## **2.3 Radiation Monitoring Systems**

The information in this section of the ABWR DCD, including all subsections, tables, and figures, is incorporated by reference with the following departures.

Figure 2.3.1 Process Radiation Monitoring System Control Interface Diagram

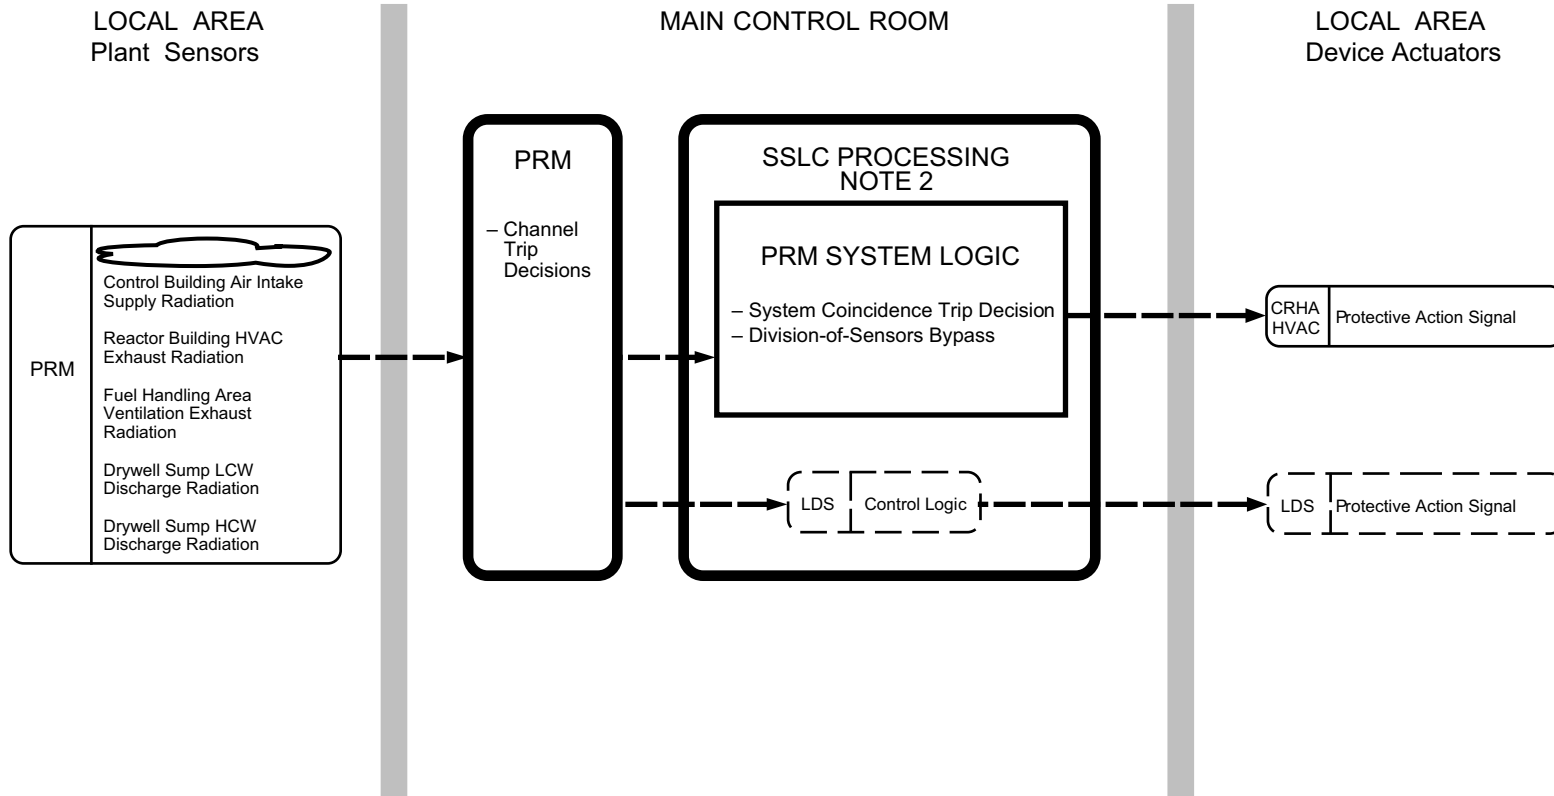
STD DEP T1 2.3-1 (Figure 2.3.1)
